Office Action Summary	Application No. 10/598,011	Applicant(s) STEINRISSER, NICULO	
	Examiner NAHID AMIRI	Art Unit 3679

DETAILED ACTION

Claims 11, 14, 15, 18, 20, 22, 24, 25, 30, and 31 are rejected under 35 U.S.C. 102(b) as being anticipated by US Patent No. 3,367,142 Groves et al.

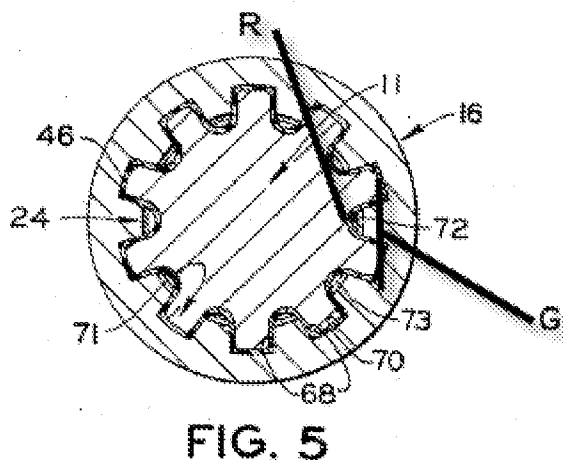
With respect to claim 11, Groves et al. disclose a groove profile (Fig. 5) for a positive hub-shaft connection comprising a hub (16) having a plurality of grooves (G, constituted by two adjacent groove) with an essentially quadrilateral groove cross section; a shaft (11) having a plurality of grooves with an essentially quadrilateral groove cross section.; and at least one rib (R) radially projecting from one of the grooves (G) of the hub (16) towards one of the grooves (constituted by two adjacent grooves of the shaft. 11) of the shaft (11).

With respect to claims 14 and 15, Groves et al. disclose (Fig. 5) that the at least one rib (R) runs parallel to a flank of the groove from which the rib (R) projects; wherein the at least one rib (R) runs along an entire length of the groove (G) from which the rib projects (R).

With respect to claim 18, Groves et al. disclose (Fig. 5) that a radius of a support surface of the at least one rib (R) imparts a connection between the hub grooves (G) and the shaft grooves that is one of free from play and under initial stress with respect to a longitudinal axis of the hub (16) or the shaft. 911).

With respect to claim 20, Groves et al. disclose (Fig. 5) that the essentially quadrilateral groove cross section is an essentially rectangular groove cross section.

With respect to claim 22, Groves et al. disclose telescopic tube (Fig.5) for drive shafts comprising an outer tube (16) having a plurality of grooves with an essentially quadrilateral groove cross section; an inner tube (11) having a plurality of grooves (G, constituted by two

With respect to claim 24, Groves et al. disclose (Fig. 5) that the inner tube and the outer tube (11, 16) are hollow bodies each with an approximately uniform profile thickness; and wherein the essentially quadrilateral groove cross section is an essentially rectangular groove cross section.

With respect to claim 25, Groves et al. disclose (Fig. 5) that the essentially quadrilateral groove cross section is an essentially rectangular groove cross section.

With respect to claim 30, Groves et al. disclose a groove profile (Fig. 5) for a positive hub-shaft connection comprising a hub (16) having a plurality of grooves (G, constituted by two adjacent groove) with an essentially quadrilateral groove cross section; a shaft (11) having a plurality of grooves with an essentially quadrilateral groove cross section.; and at least one rib (R) radially projecting from one of the grooves (G) of the hub (16) towards one of the grooves (constituted by two adjacent grooves of the shaft. 11) of the shaft (11); and wherein the at least one rib (R) is formed in one piece from a material of the groove from which the at least one rib (R) project.

With respect to claim 31, Groves et al. disclose (Fig. 5) that the at least one rib (R) is formed in one piece from a material of the groove from which the at least one rib (R) project.

FIG. 5

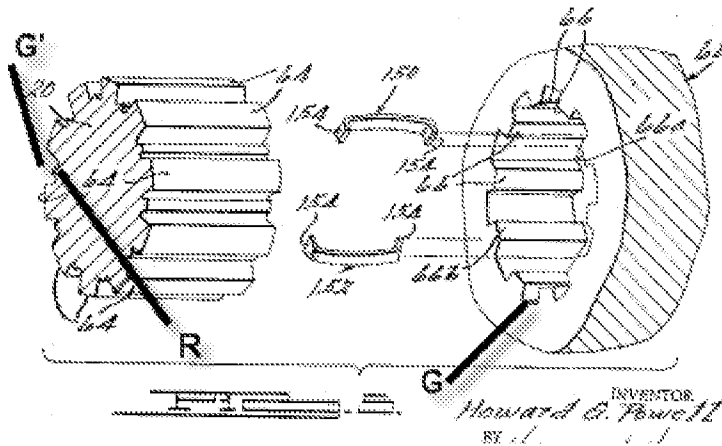
With respect to claim 11, Powell discloses a groove profile (Fig. 5) for a positive hub-shaft connection comprising a hub (68) having a plurality of grooves (G) with an essentially quadrilateral groove cross section; a shaft (20) having a plurality of grooves (G') with an

essentially quadrilateral groove cross section; and at least one rib (R) radially projecting from one of the grooves (G') of the shaft (20) towards one of the grooves (G) of the hub (68).

With respect to claims 14 and 15, Powell discloses (Fig. 5) that the at least one rib (R) runs parallel to a flank of the groove from which the rib (R) projects; wherein the at least one rib (R) runs along an entire length of the groove (G') from which the rib projects (R).

With respect to claim 18, Powell discloses (Fig. 5) that a radius of a support surface of the at least one rib (R) imparts a connection between the hub grooves (G) and the shaft grooves (G') that is one of free from play and under initial stress with respect to a longitudinal axis of the hub (68) or the shaft (20).

With respect to claim 20, Powell discloses (Fig. 5) that the essentially quadrilateral groove cross section is an essentially rectangular groove cross section.

With respect to claims 30 and 31, Powell discloses a groove profile (Fig. 5) for a positive hub-shaft connection comprising a hub (68) having a plurality of grooves (G) with an essentially quadrilateral groove cross section; a shaft (20) having a plurality of grooves (G') with an essentially quadrilateral groove cross section; at least one rib (R) radially projecting from one of the grooves (G') of the shaft (20) towards one of the grooves (G) of the hub (68); and at least one rib (R) is formed in one piece from a material of a groove (G') from which the at least one rib (R) project; and wherein the at least one rib (R) is formed in one piece from a material of the groove from which the at least one rib (R) project.
